# IEC / IEEE 60802 - IA profile

IEEE802.1Q identified gaps –

Rules for gates control vs. inter packet gap

# Gate open - Inter packet gap is where?

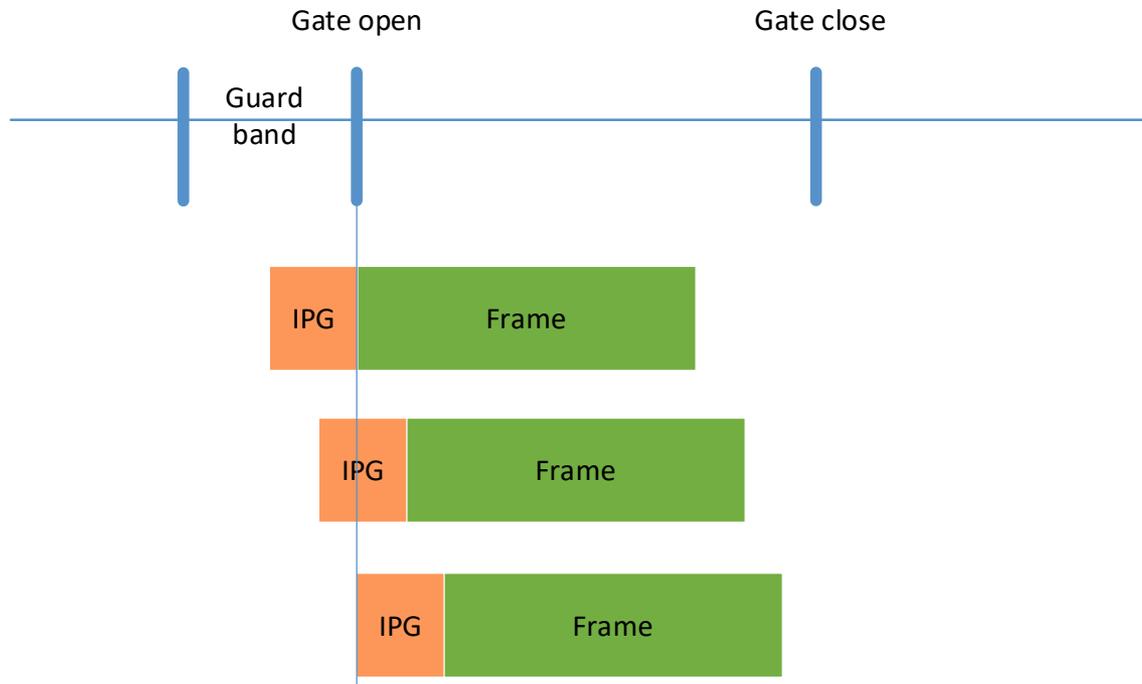
What is the rule?

Outside, inside or undefined?

# Gate close - Inter packet gap is where?

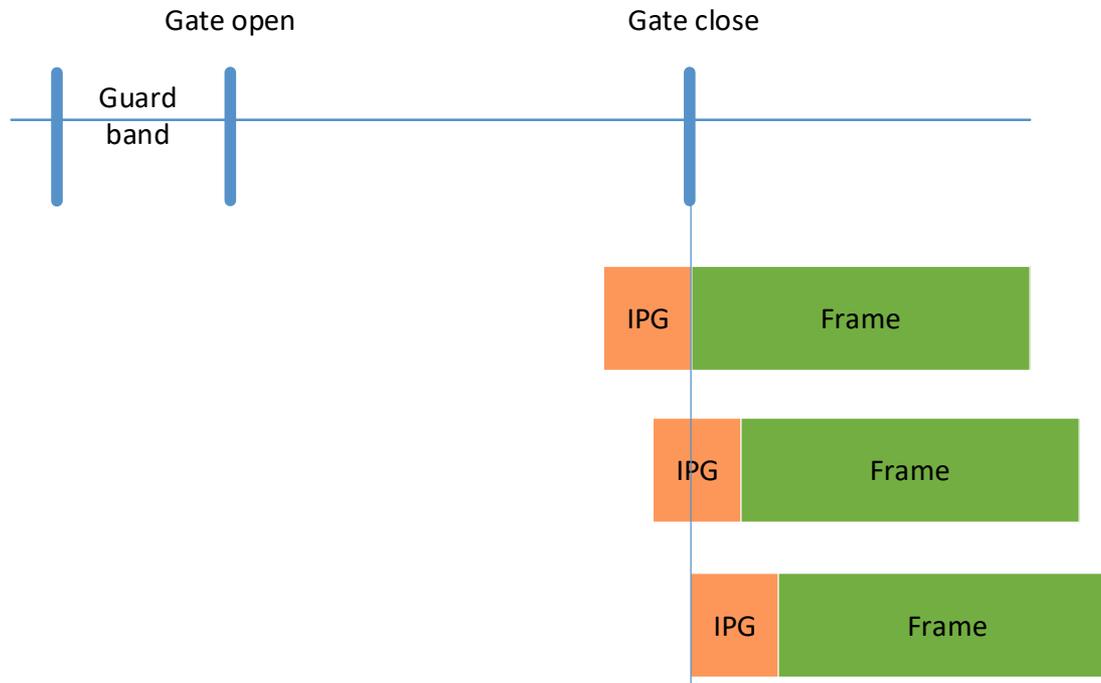
What is the rule?

Outside, inside or undefined?
